**FAQ Number** 07-0038 Revision 2

**FAQ Title** Lessons learned on Multiple Spurious Operations

Plant: Turkey Point

Date: June 30, 2010

**Figure XX – Multiple Spurious Operations – Transition Resolution Process**

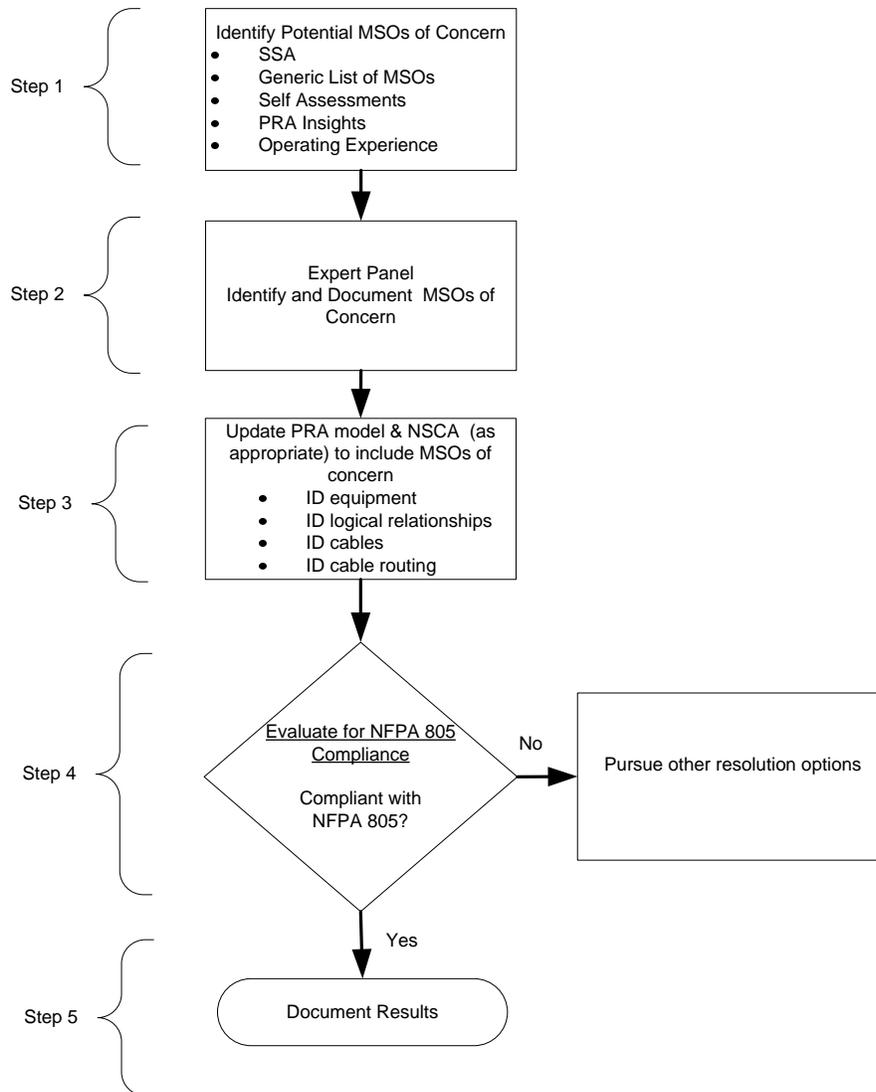
The approach outlined in Figure XX below is one acceptable method to address fire-induced MSOs. This method uses insights from a Fire PRA that meets the requirements of Regulatory Guide 1.205, Revision 01.

### **Step 1 - Identify potential MSOs of concern.**

### **Step 2 - Conduct an expert panel to assess plant specific vulnerabilities (e.g., per NEI 00-01, Rev. 1 Section F.4.2).**

### **Step 3 – Update the fire PRA model and NSCA to include the MSOs of concern.**

### **Step 4 – Evaluate for NFPA 805 Compliance**

### **Step 5 - Document Results**
